**MAJOR MODIFICATION**

**OPERABLE UNIT 1: 881 HILLSIDE AREA**

**CORRECTIVE ACTION DECISION/RECORD**

Rocky Flats Environmental Technology Site  
Golden, Colorado

Figure 3. OU 1 Collection Well Trichloroethene Concentrations and Projection.

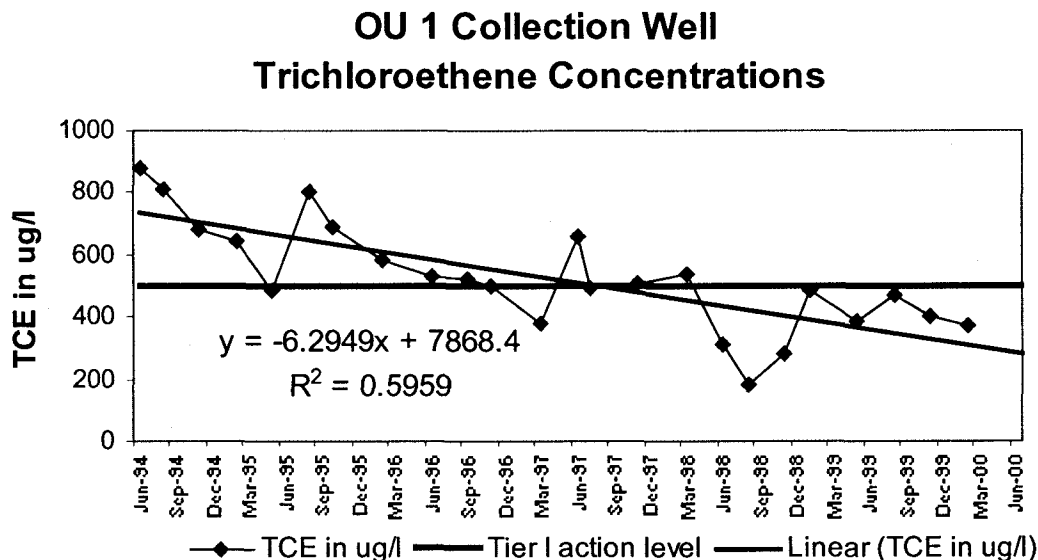
Comment: A correlation of Trichloroethene (TCE) concentrations to the water table levels reflected in the OU1 collection well needs to be completed. Such a graph would give a more complete picture of the TCE values relative to the water table. There is a possibility that the natural ebb and flow of the underlying water table could directly impact the TCE concentrations. Breaching the French Drain before the water balance study is complete would be premature. Removing the Drain eliminates a line of defense for surface water and emphasizes the need to include an evaluation of impacts to surface water.

Comment: The downward trend of data in the OU 1 Collection Well chart could reflect the decreasing availability or effectiveness of the contamination transport medium and that the source of contamination at IHSS 119.1 has been removed. If the scenario that I have presented is correct, the contamination is still present and just lacking sufficient groundwater to transport it down gradient.

Response: The simple regression was based on data available since the Collection Well was installed in 1992 and indicates a general declining trend but also shows seasonal and weather-related variability. A regression based on the average annual concentrations resulted in an r-squared value of 0.82 corroborating the declining trend. In addition, when data from the Collection Well were segregated by quarter, to eliminate seasonality, each quarter's results also show strong declining trends.

However, rather than relying only on the linear regression model, additional data have been provided in the document that discusses the natural attenuation processes that are taking place and causing the decline in concentrations. Data are also now included from the downgradient well, which exhibits a strong decline in concentrations further supporting natural attenuation. Low groundwater flow rates (calculated at 70 feet per year) combined with the natural attenuation processes known to be occurring preclude the potential for impacts to surface water from higher concentrations.

Response: As stated above, an investigation was completed to locate a contaminant source in or near IHSS 119.1. The investigation results led to the conclusion that a source was not present which could be remediated. Groundwater results support this conclusion. Based on this evidence, a source is not present in the IHSS 119.1 area.

Figure 1

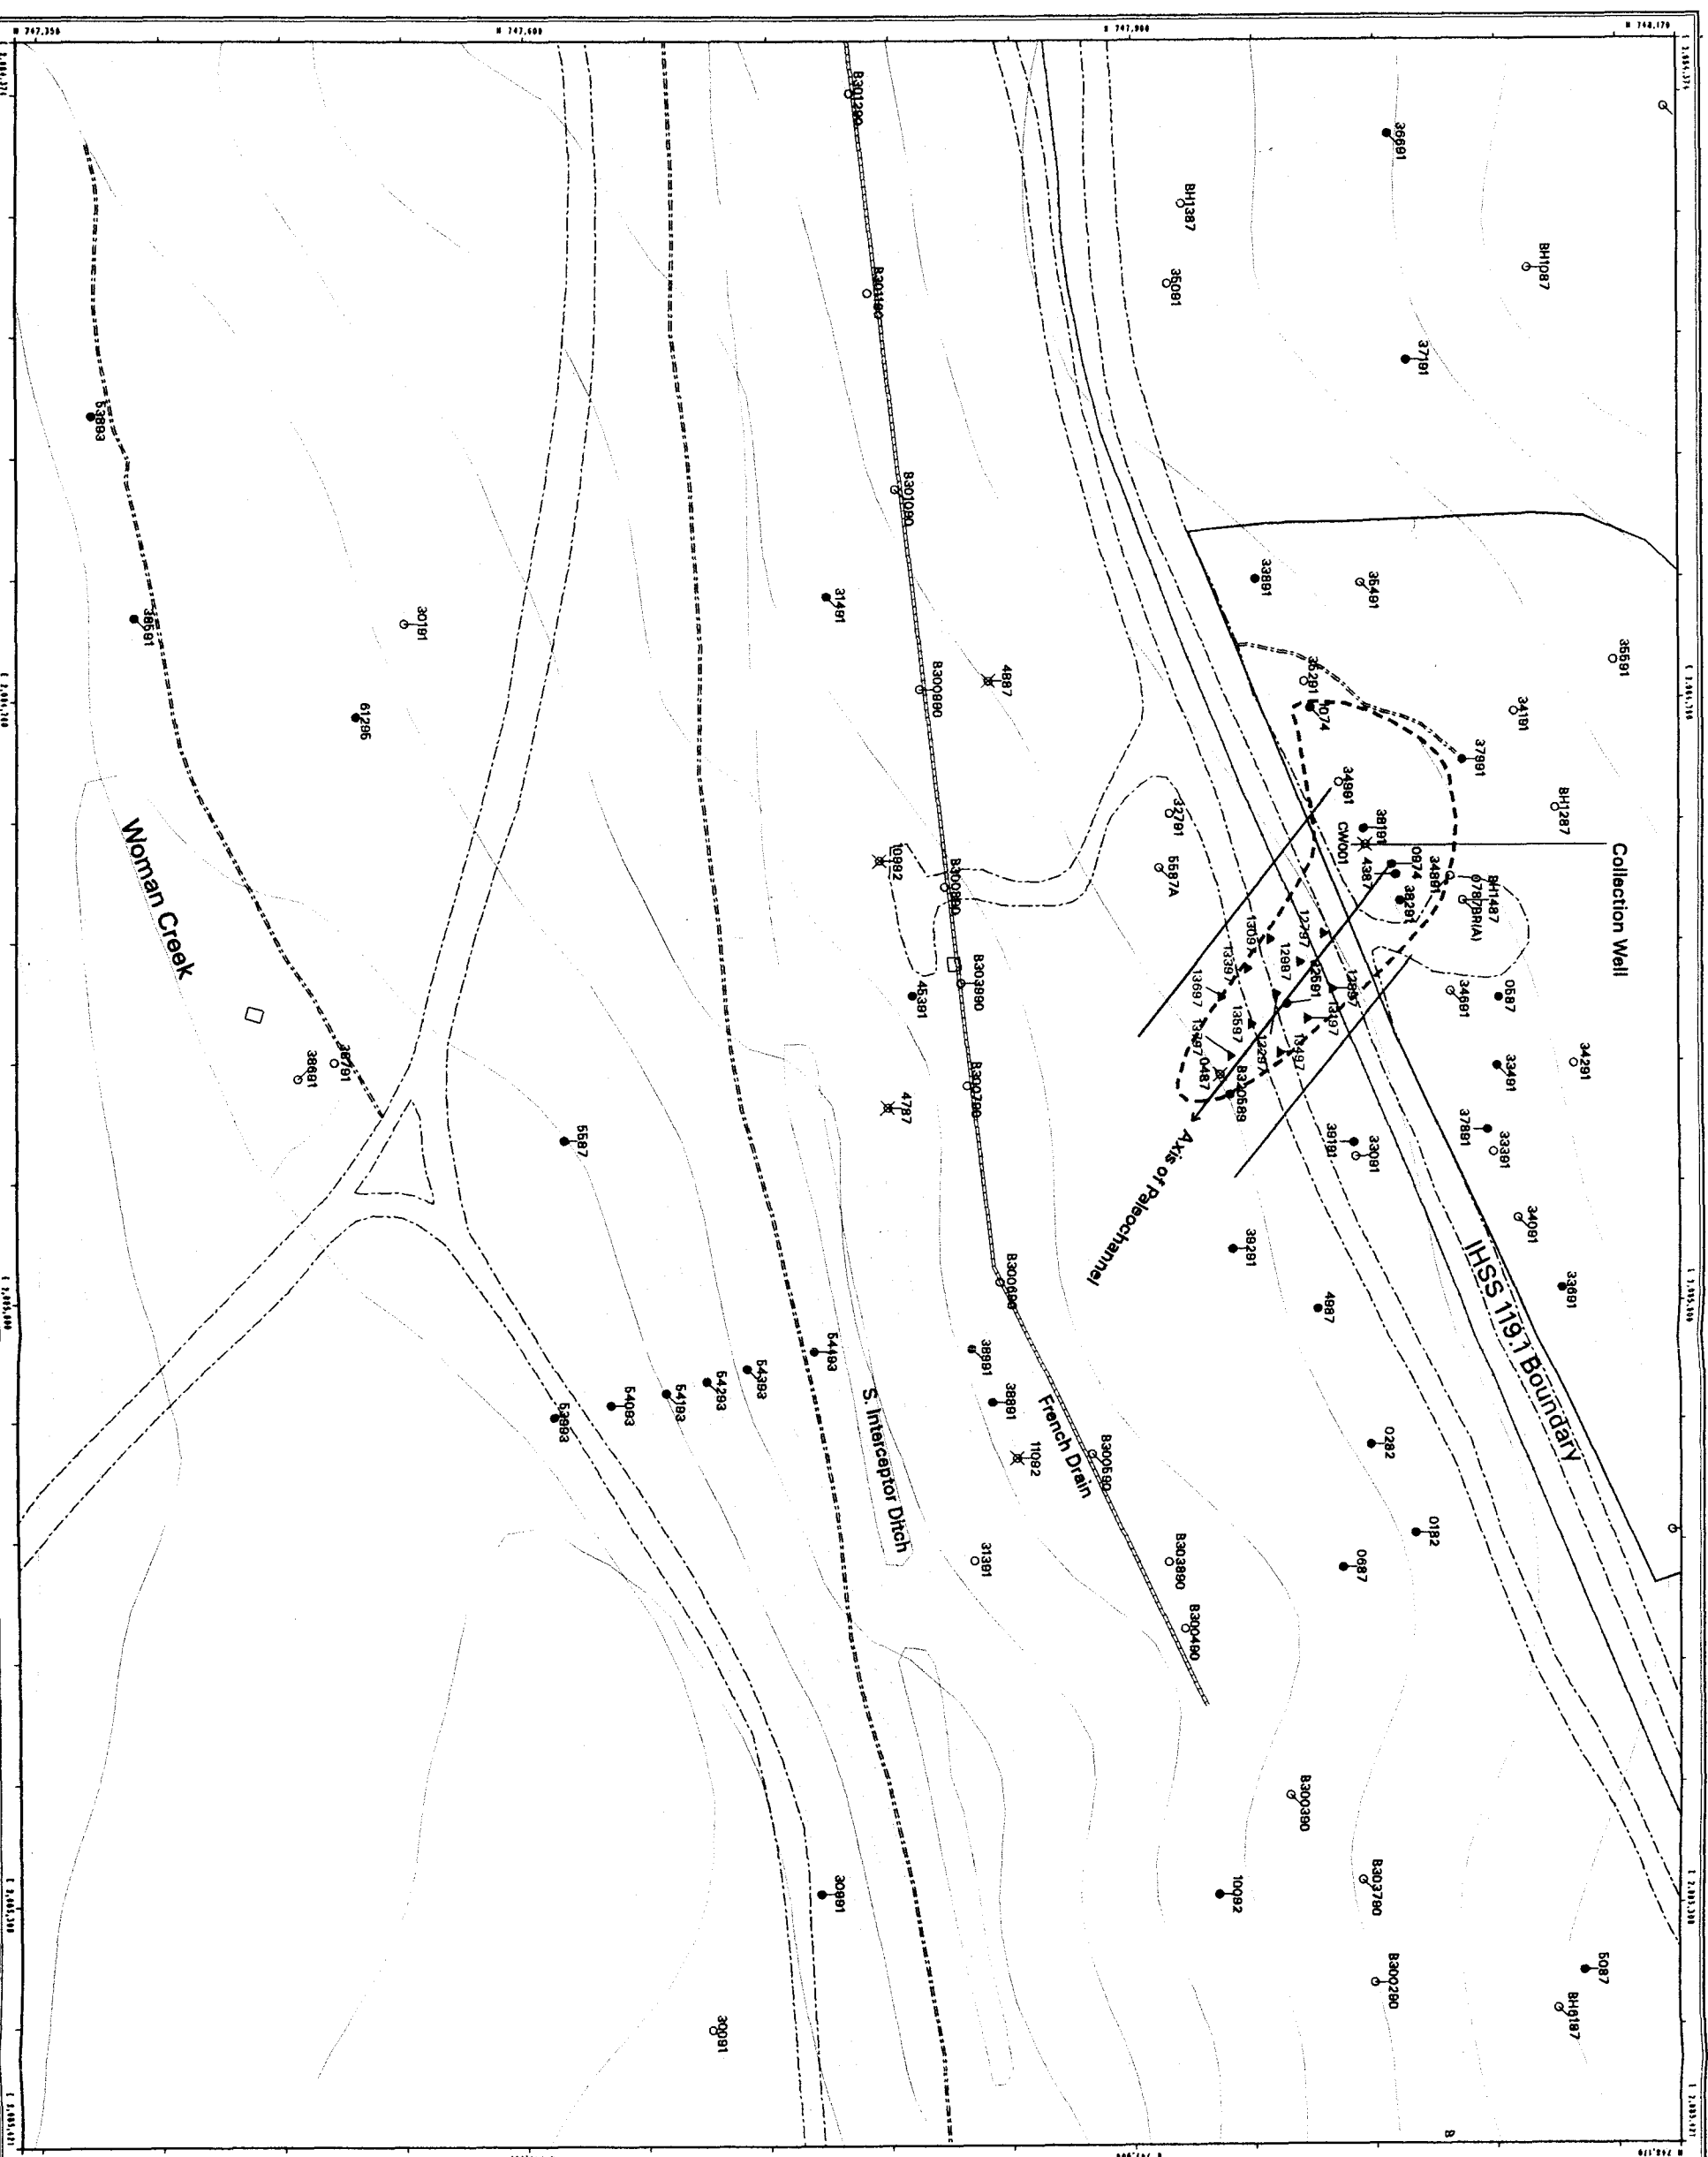
Comment: The declining trend identified in Figure 1 is not reflective of statistical means, nor does the figure correlate concentrations to dry seasons or wet seasons. Figure 1 reflects a linear regression, not a statistical regression; therefore, Tier I levels may be exceeded in the future. Broomfield agrees with the EPA's recommendations to continue collection of the groundwater to reduce the concentration of TCE to a level approximating the Tier II groundwater value. The City of Broomfield recommends collection and treatment of groundwater to continue until Tier II values are achieved for a continuous two-year period to ensure concentrations of TCE are stable and below Tier I levels during wet seasons. Continuing the treatment and removal of TCE ensures there will be protection of surface water standards. DOE assumed natural attenuation will occur, therefore reducing the impact to surface water. DOE also assumes the linear regression model accurately represents the system, but seasonal precipitation is a variable that is not factored into the linear regression model. What modeling was used to confirm surface water would not be impacted at levels two orders of magnitude or less? Broomfield would appreciate the opportunity to review the modeling performed.

Response: We appreciate Broomfield's visit to the Site on August 11<sup>th</sup>. The following responses summarize the data provided and also provide additional clarification. Water quality and volume data for the Collection Well and French Drain were provided to Broomfield on August 15<sup>th</sup>.

There are declining concentrations at both the Collection Well and the downgradient well. As noted, there are seasonal variations in the TCE concentrations at the Collection Well. However, even with these variations, contaminant concentrations are consistently below Tier II action levels in the French Drain. This evaluation, now included in the modification, shows that there is no impact to surface water.

No additional modeling was performed, however, a discussion of the natural attenuation processes causing the declines in contaminant levels and limiting the extent of the OU1 Plume are now included, along with a map showing the locations of the pertinent features. This discussion includes data from the downgradient well and French Drain that show surface water quality was not and will not be impacted by the OU1 plume. Surface water is demonstrated to be protected at the current contaminant concentrations in the Collection Well. However, pumping the Collection Well will continue for one more year. The Collection Well will remain in place and be monitored through Site Closure. Evaluation and/or actions will be triggered if the downward trend of TCE is not sustained and concentrations consistently are above Tier I action levels.
